As-built Baseline Monitoring Report

Bear Swamp Stream & Wetland Mitigation Project

RE: Response to Draft As-Built Baseline Monitoring Report (MY0) Comments dated June 7, 2021
Bear Swamp Stream & Wetland Mitigation Project
Lumber River Basin – CU# 03040203 - Robeson County, North Carolina
NCDMS Project # 100054, Contract # 7516

BEAR SWAMP STREAM AND WETLAND RESTORATION SITE
 CURRENT CONDITION PLAN VIEW: ASSET MAP
 MYO: 2021
 ROBESON COUNTY, NC

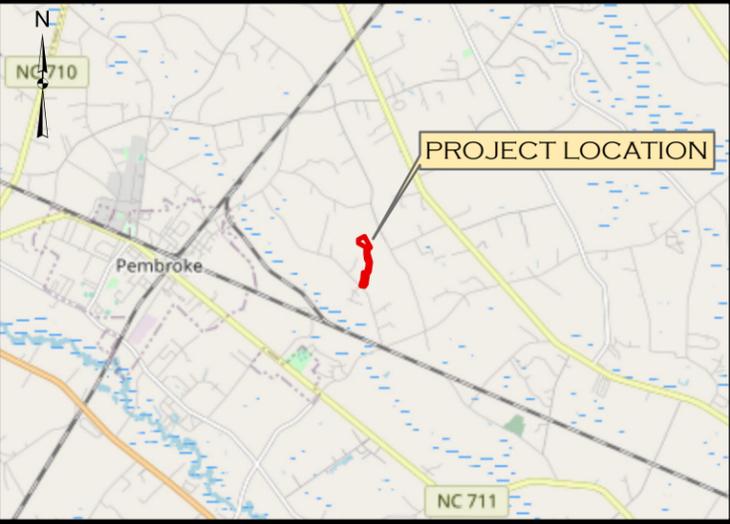
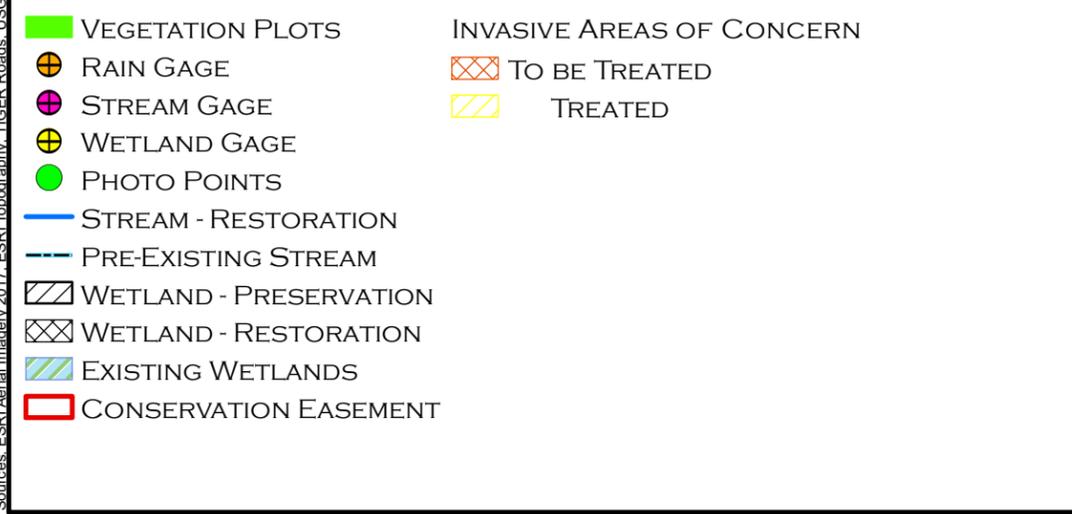
- *Please add wetland polygons to the maps.*
 - **Pre-existing jurisdictional wetlands have been added to the CCPV. The wetland preservation and restoration polygons are also shown.**

- **See previous response regarding where this information has been added to the Baseline report.**
- *Table 5 shows some areas as “invasive areas of concern.” Please map these areas and show on CCPV.*

- *In the future, please provide CCPV on one page with labels. This site is too small to be broken out into two maps.*
 - **The CCPV has been reformatted to one page.**

- **These areas have been added to the CCPV.**
- *Table 3 shows wetland C with ‘Norfolk’ soil, which is non-hydric. Update to provide correct soil series or leave blank and describe as hydric.*

PLAN / PROFILE

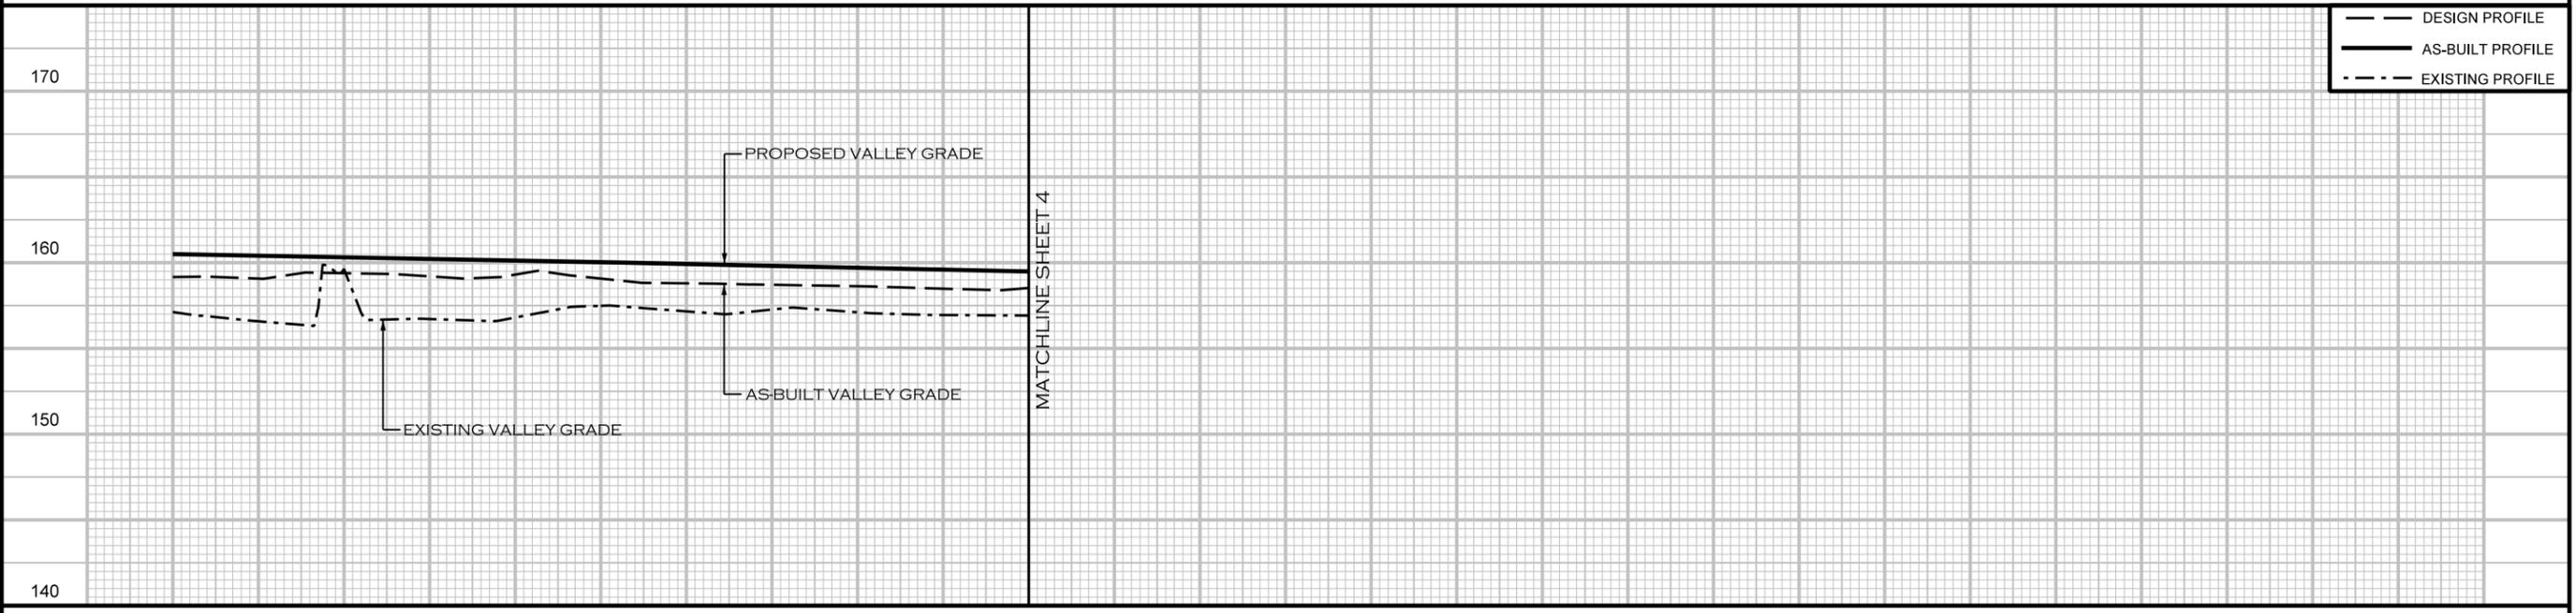
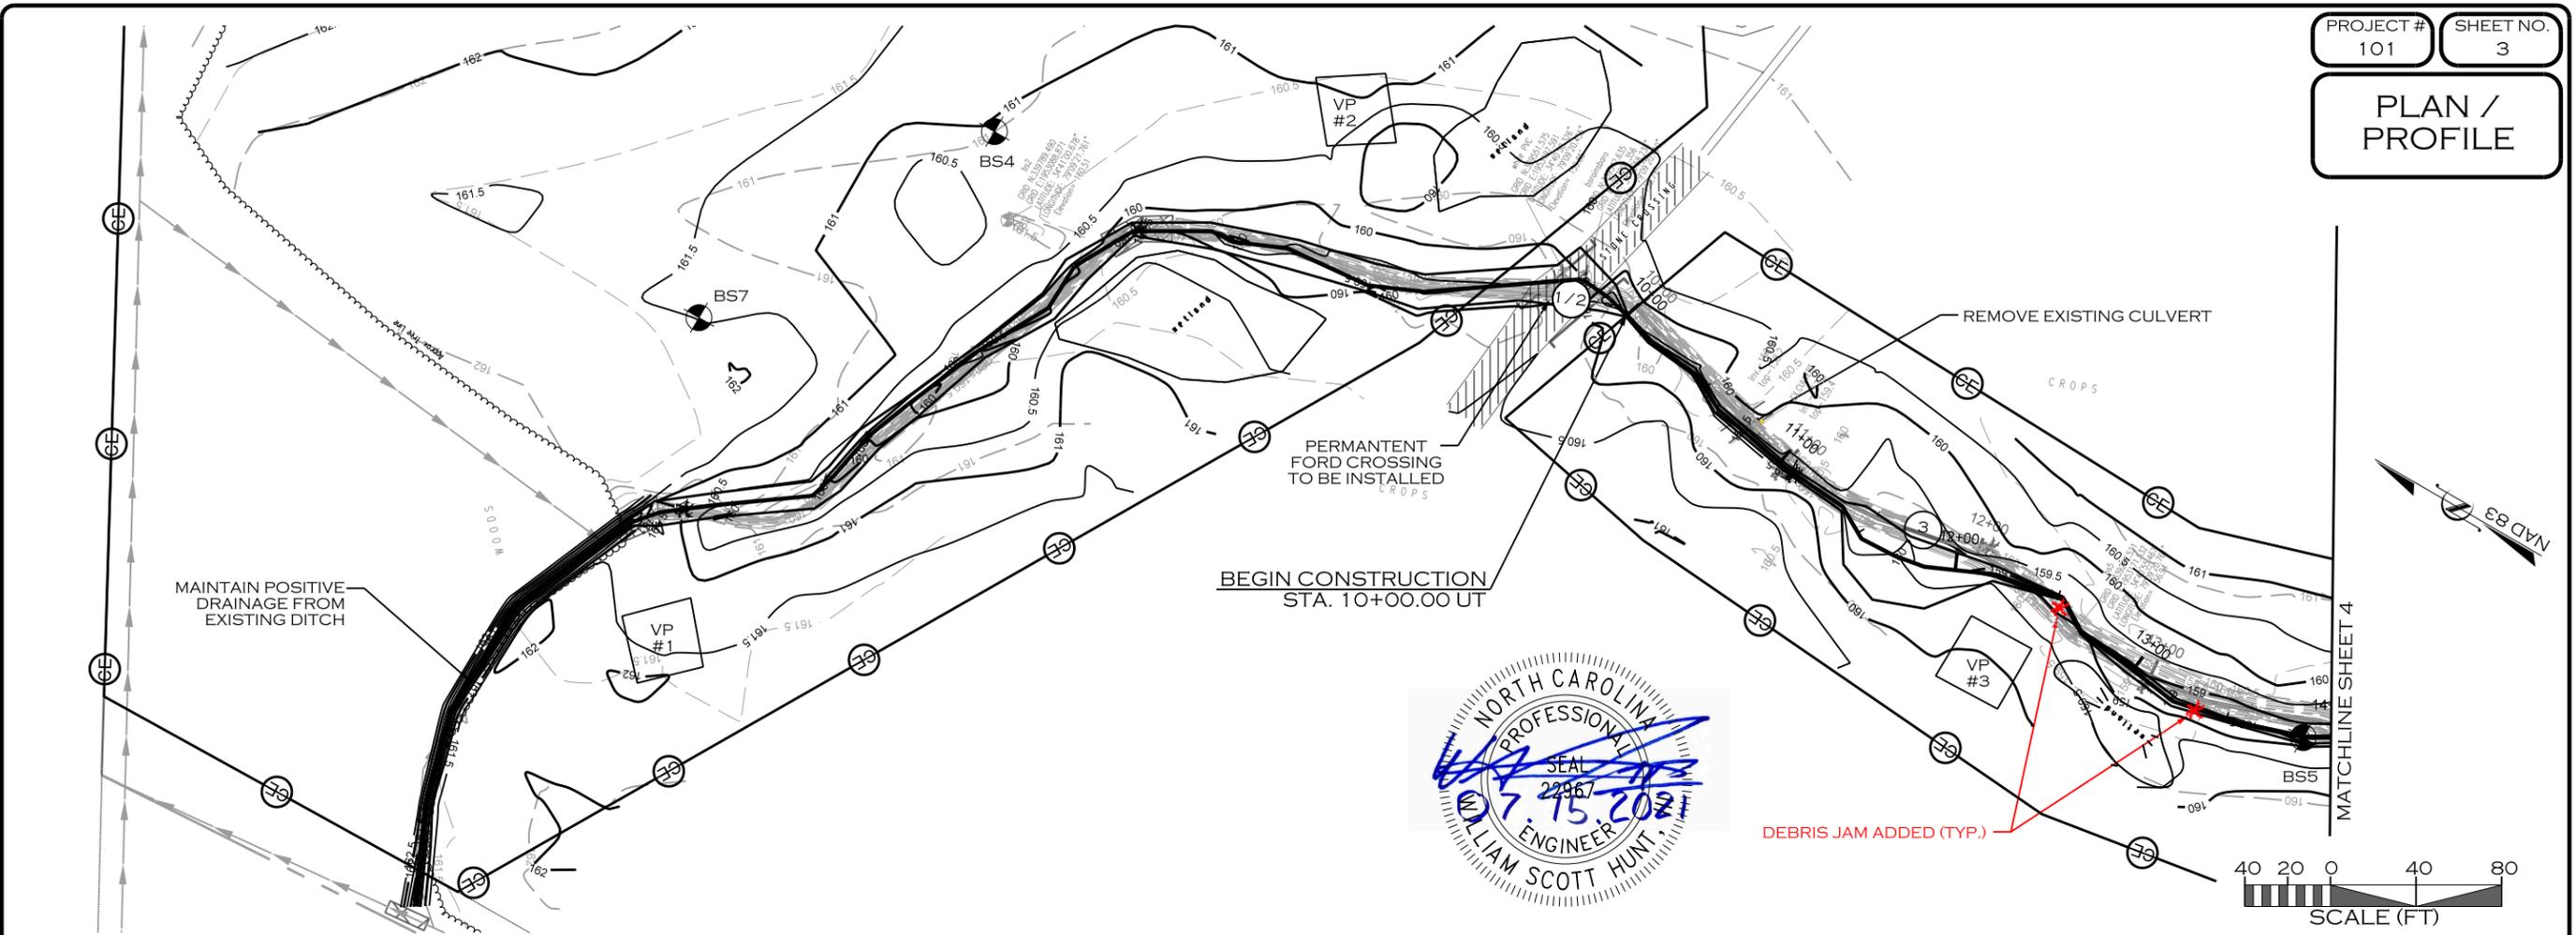
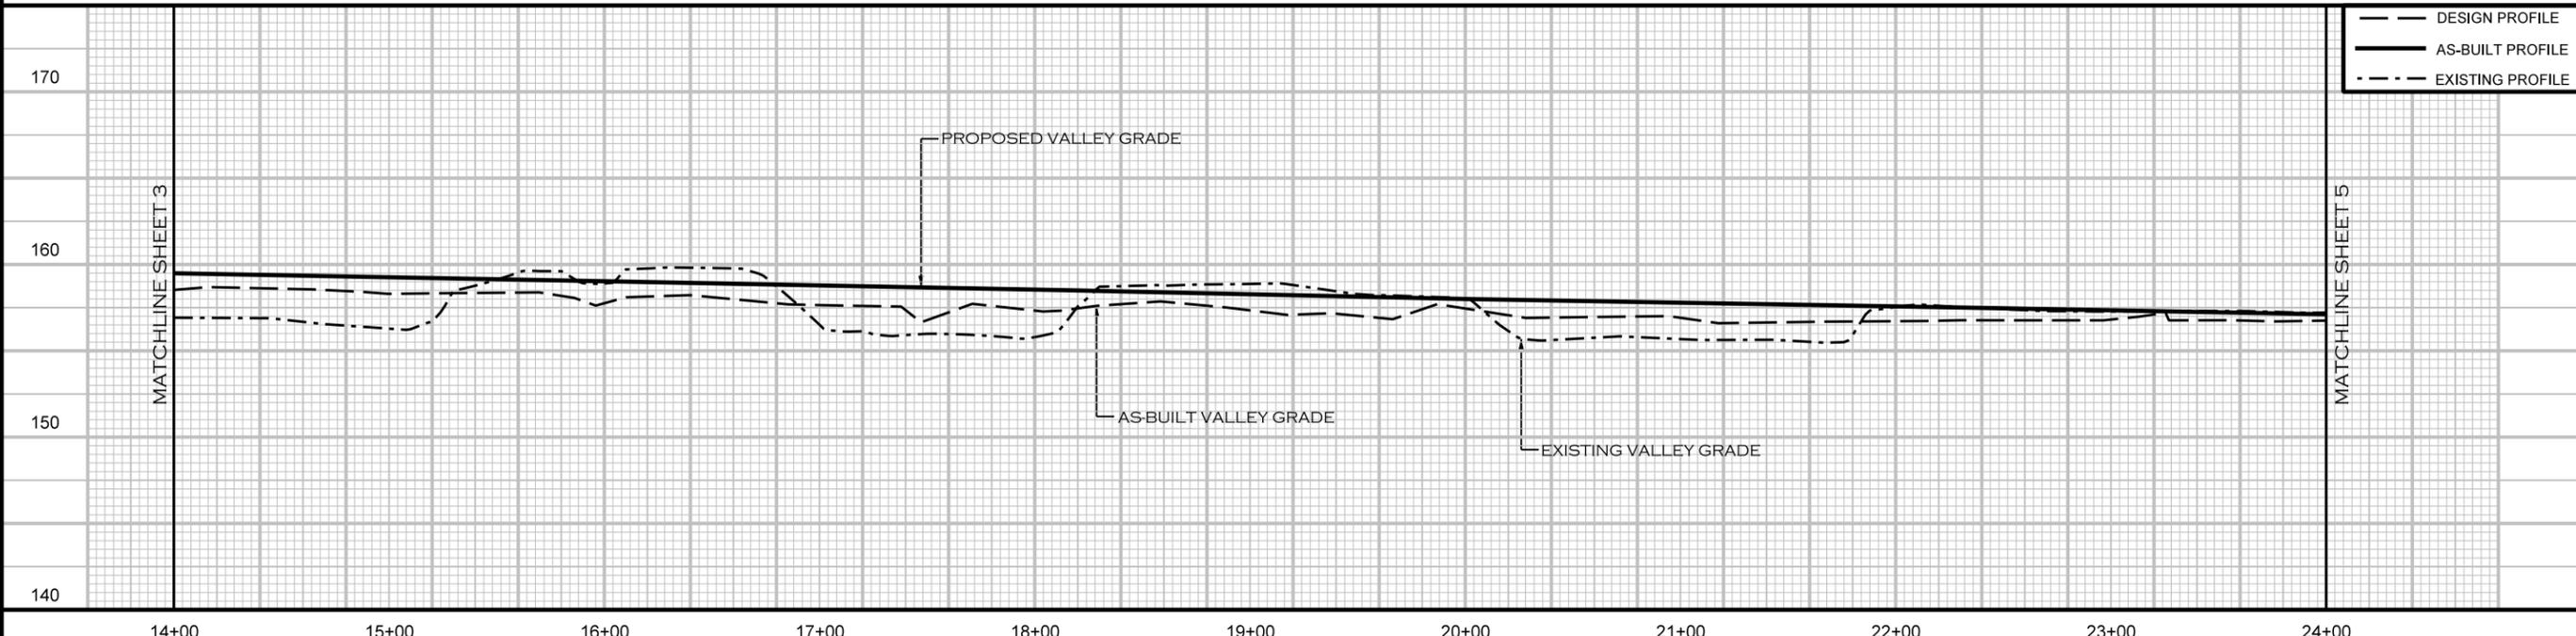
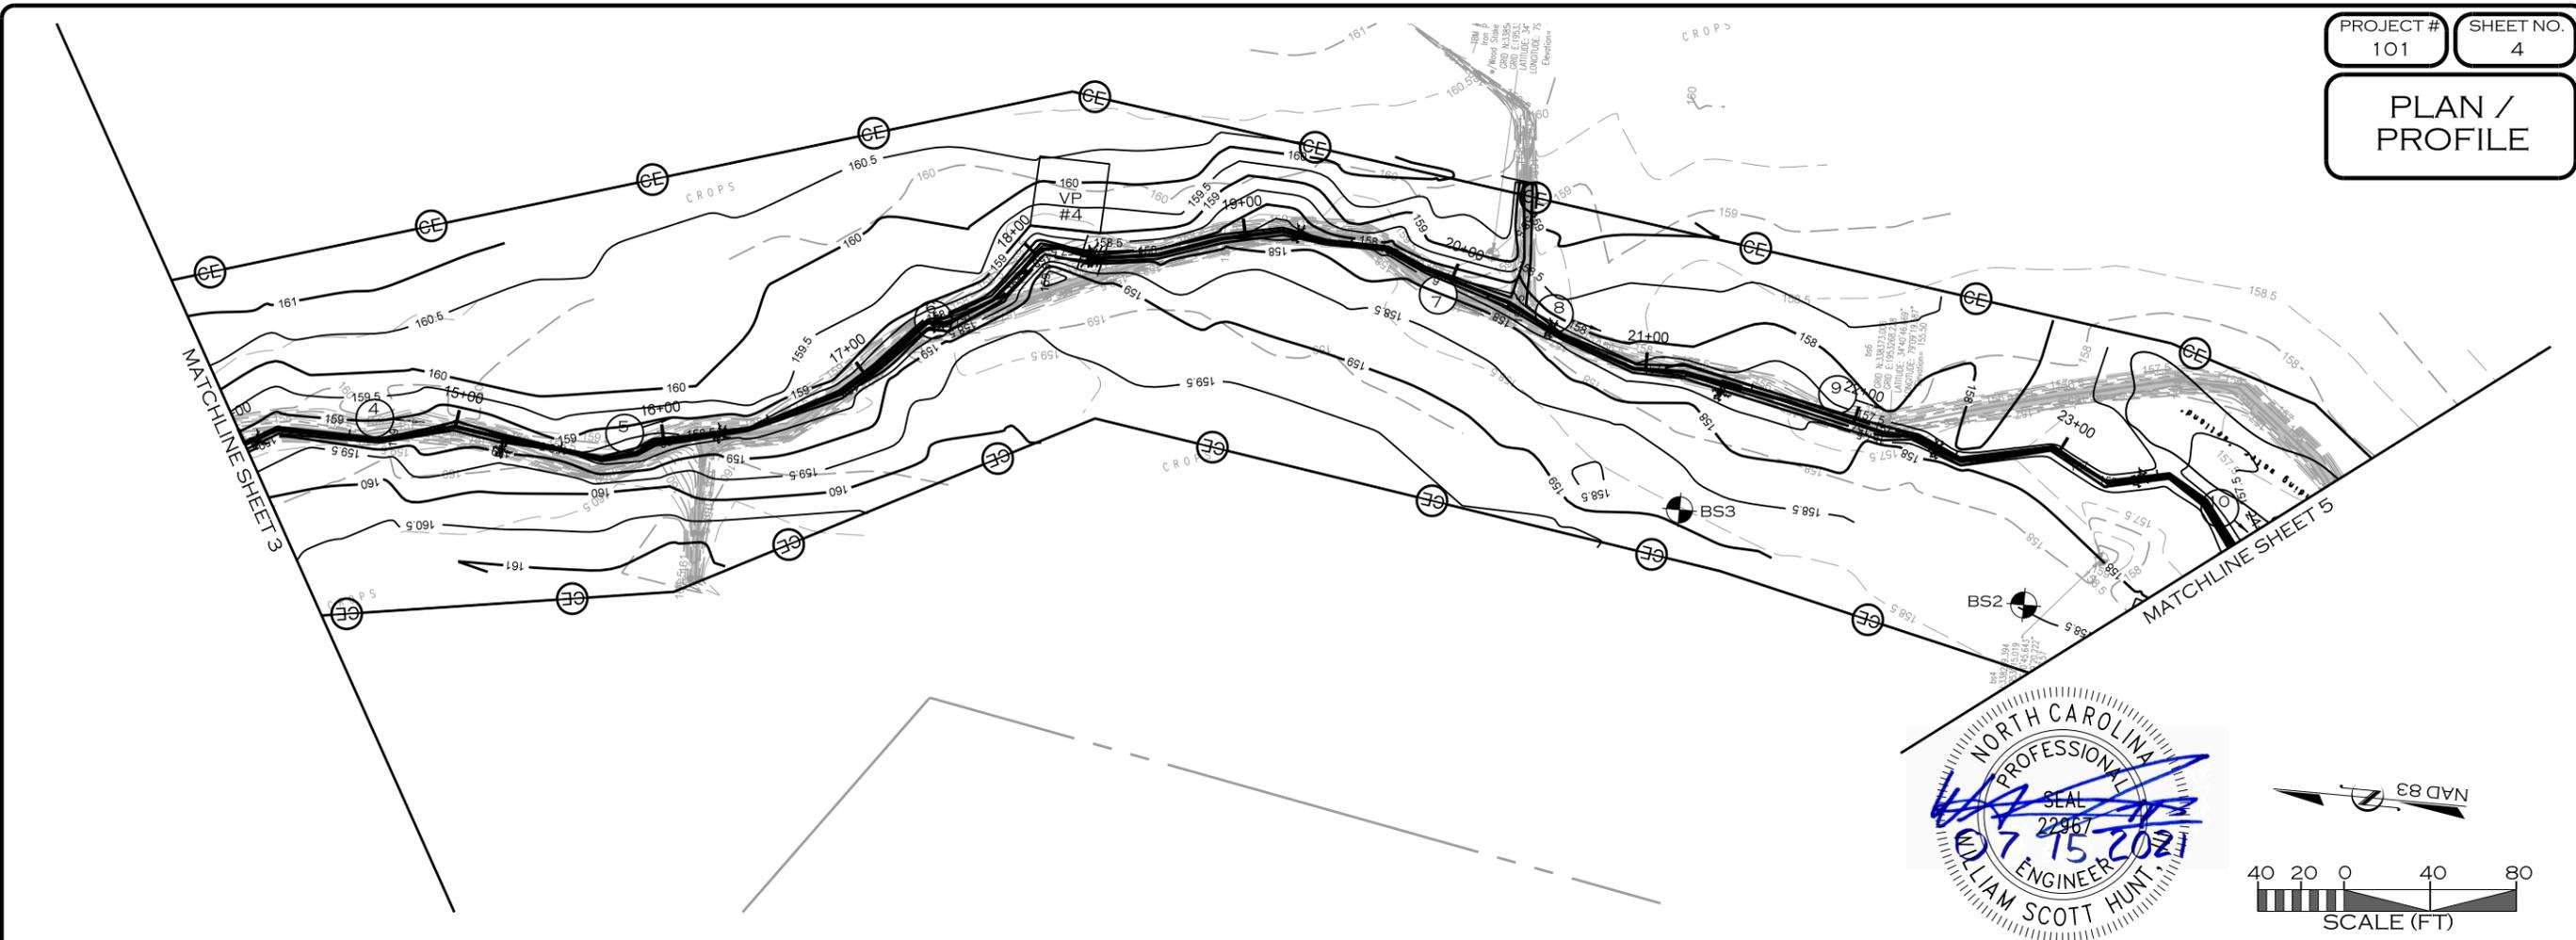
- *Long pro is showing on drawings, but difficult to see because of scale and background. Can the previous ditch depth be graphed to show elevation change and background turned off?*

- **The vertical scale on the profile was increased on sheets 3, 4, and 5 to improve legibility. Where the previous ditch ties in with the existing ground on sheet 5 the elevations are so similar that increasing the scale and/or turning off the background does not greatly improve legibility.**
